**THE CORPORATION OF THE TOWNSHIP OF TINY**

**CONFIDENTIAL**  
**PLANNING & DEVELOPMENT REPORT PD-004-20**

**RE:** Application: Teedon Pit Extension  
Aggregate Resources Act Application  
Owner(s)/Applicant(s): CRH Canada Group Inc.  
Legal Description: North Part of Lot 80, Concession 1 O.S.  
(Appendix 1)  
Municipal Address: 2 Darby Road  
File: '19/D05 (DS #62762)  
Roll No. 1-029-00

## 2018 CURRENT PROPOSAL

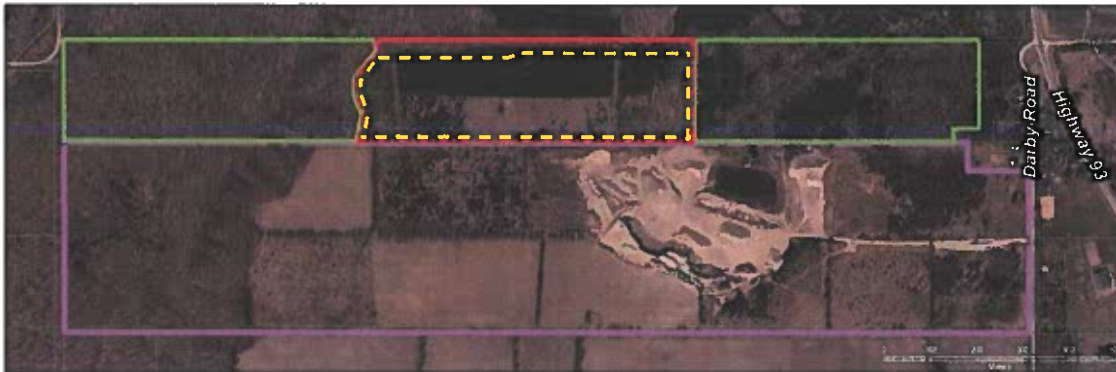
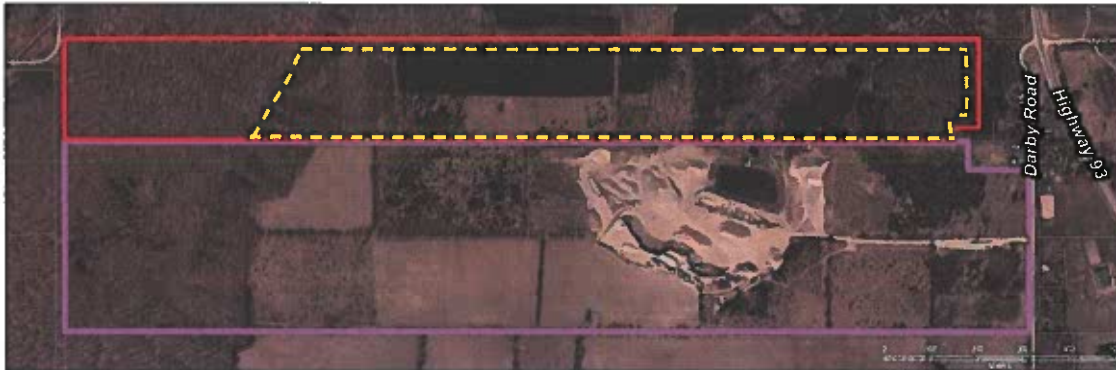
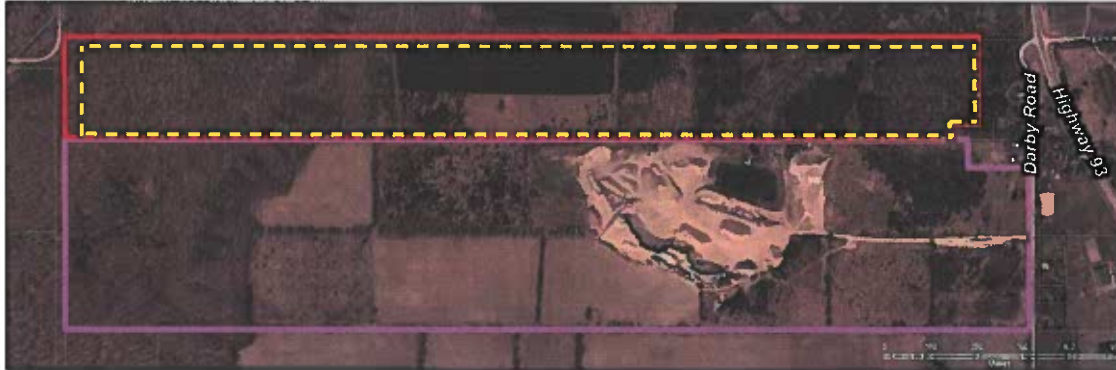
## 2013 REVISED PROPOSAL

## 2011 ORIGINAL PROPOSAL
